SEWAGE DISPOSAL SYSTEM

P 50988B

HOWARD COUNTY HEALTH DEPARTMENT
BUREAU OF ENVIRONMENTAL HEALTH

SUBDIVISION Marriott Manor LOT Parcel 3 ROAD 11432 Old Frederick Road

P 50988B

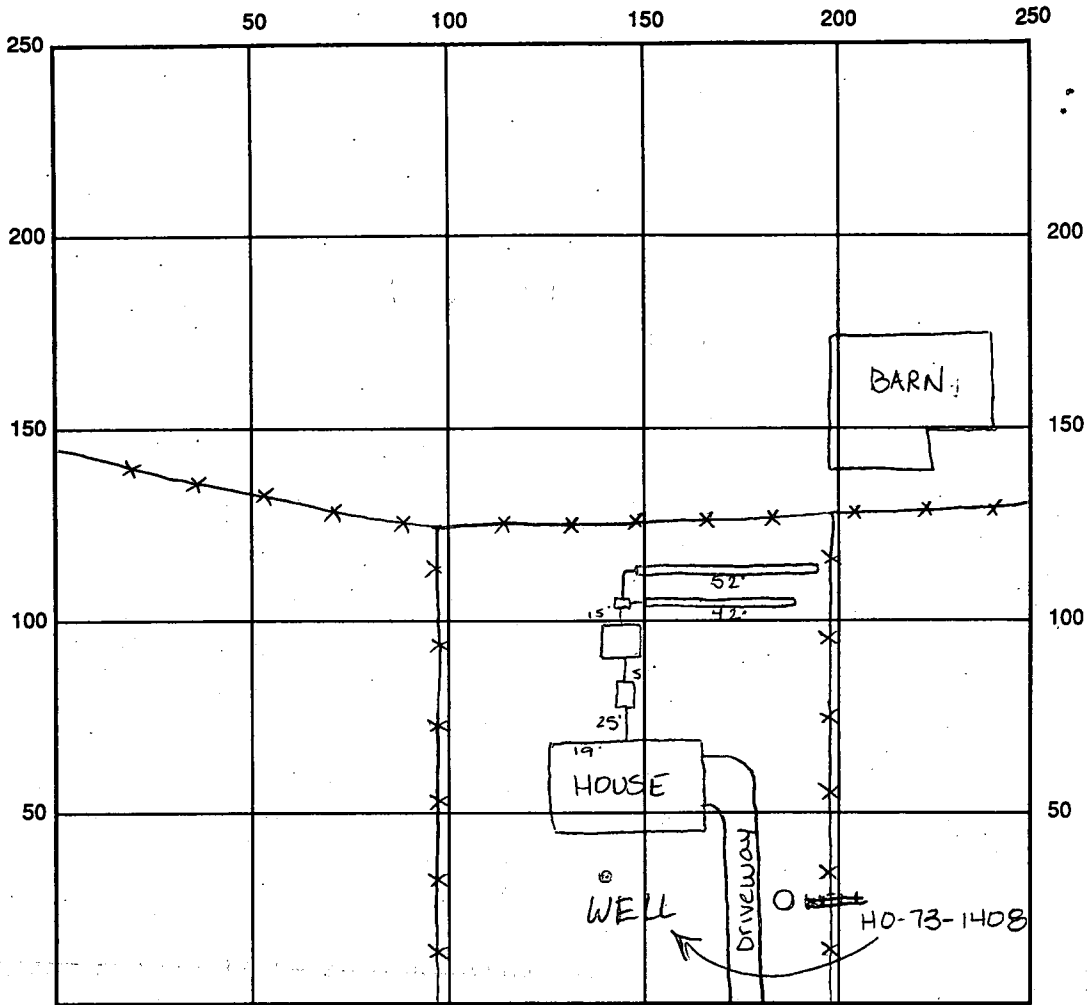
CLEANOUTS cleanouts to grade put on tank & dry well

DISTRIBUTION BOX LEVEL OK baffle is in

REMARKS: 11-27-95 OK to cover all work final (all lines replaced w/

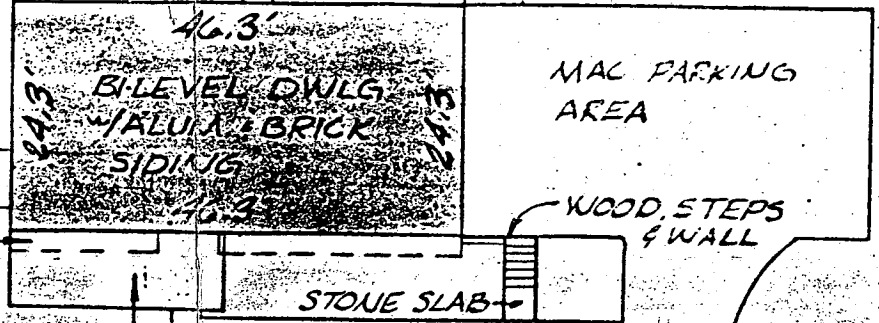
6/18/86 ST UNDER CENTER
PORTION OF DECK APPROX.
5 FT. OWNER WILLING TO ACCEPT
RESPONSIBILITY TO REMOVE DECK
IN ORDER TO ACCESS TANK FOR
REPAIRS AND PUMPED. REMAINING
OPTION IS TO MOVE TANK.

6/11/86 - Deck is
installed - could
not locate capture
tanks or septic area

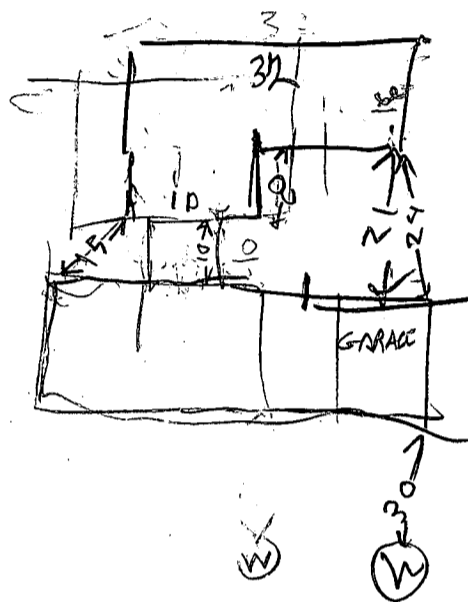
PIPE PROBABY
COMES OUT
AT LAUNDRY
ROOM

- ① Could not find septic but probably near deck
- ② Does not know Lot # but will have husband
- ③ check Lot #
- ④ checked Lot 3 Marriott manor
